**OPTIONAL SERVICE BULLETIN NO. OSB D4-115 REV. 0**

Type: DA 40 D

Vertical stabilizer rivet nuts replacement by anchor nuts.

## **WORK INSTRUCTION WI-OSB D4-115 REV. 0**

Figure 1. VS-HS fairing removal.

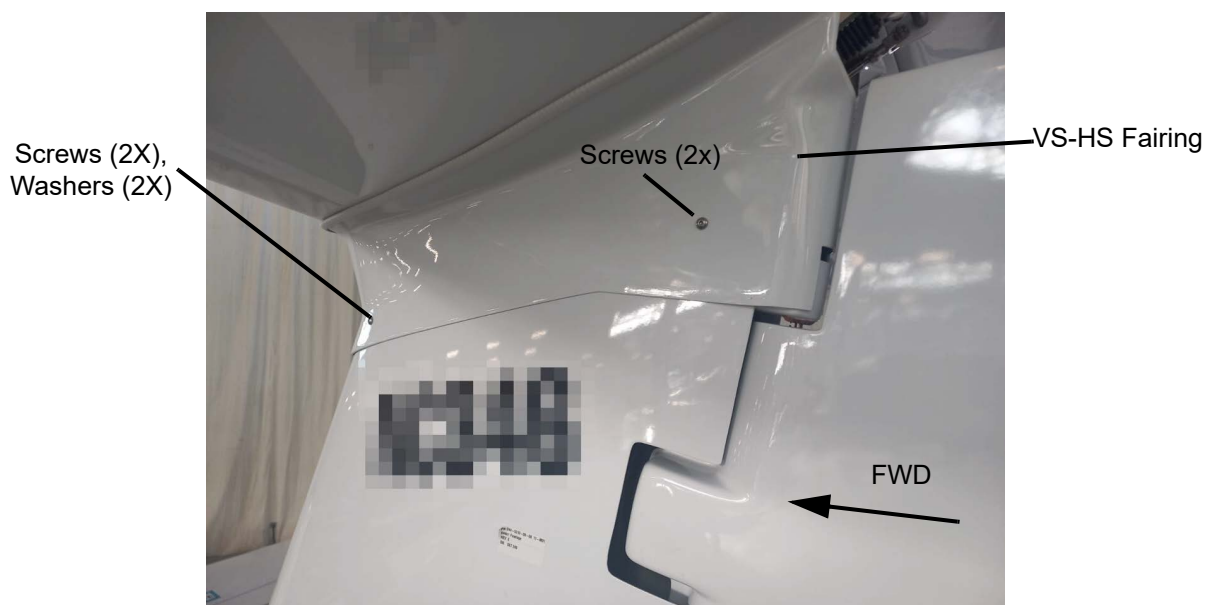
1. Remove the 4 screws and 2 washers which attach the VS-HS fairing. Refer to Figure 1.

Figure 2. Anchor nut installation.

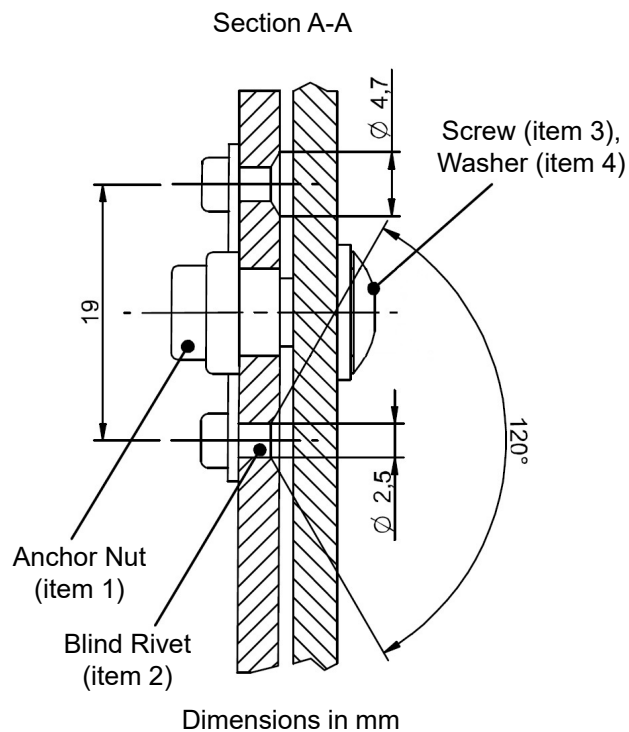
5. To install the 2 anchor nuts (item 1) at the same installation points of the rivet nuts, drill the vertical stabilizer to install the 4 blind rivets (item 2). Refer to Figure 2.

Figure 3. Anchor nuts installed on the vertical stabilizer

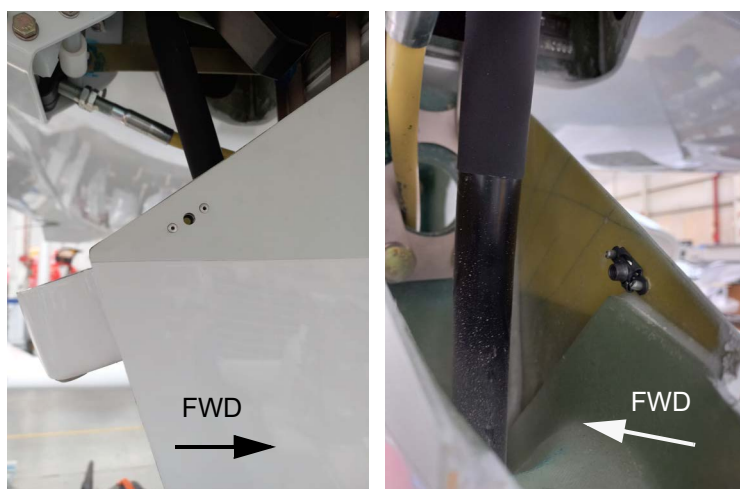
6. Install the 4 blind rivets (item 2) to attach the 2 anchor nuts (item 1) to the vertical stabilizer. Refer to Figures 2 and 3.
